BAC BIRK AEROSYSTEMS CORP. GARDEN GROVE, CA.	DOCUMENT CHANGE NOTICE	<input type="checkbox"/> ADCN <input checked="" type="checkbox"/> DCN NO. 5990 Sheet 1 of 1
---	-----------------------------------	---

Document Title: INFORMATION SIGN, LED TYPE	Document. No.: IS5194	Rev. Letter: A	Release Date: 12-09-05
--	---------------------------------	--------------------------	----------------------------------

DWG NO. IS5194
 SHEET 1 OF 2
 REV. A

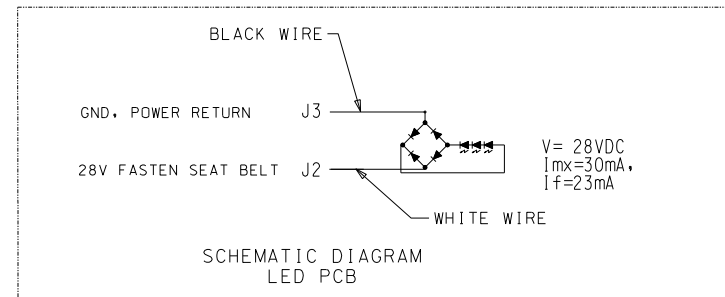
- 1) SHEET 2, ZONE 3C: IS: INSULATED TAB, TE P/N 2-520102-2
WAS: INSULATED TE FLAG RECEPTACLE, 5-520128-2
- 2) SHEET 2, ZONE 3C: IS: J3 J2 WAS: J1 J2
- 3) SHEET 1, ZONE 2C: IS: J3 J2 WAS: J1 J2
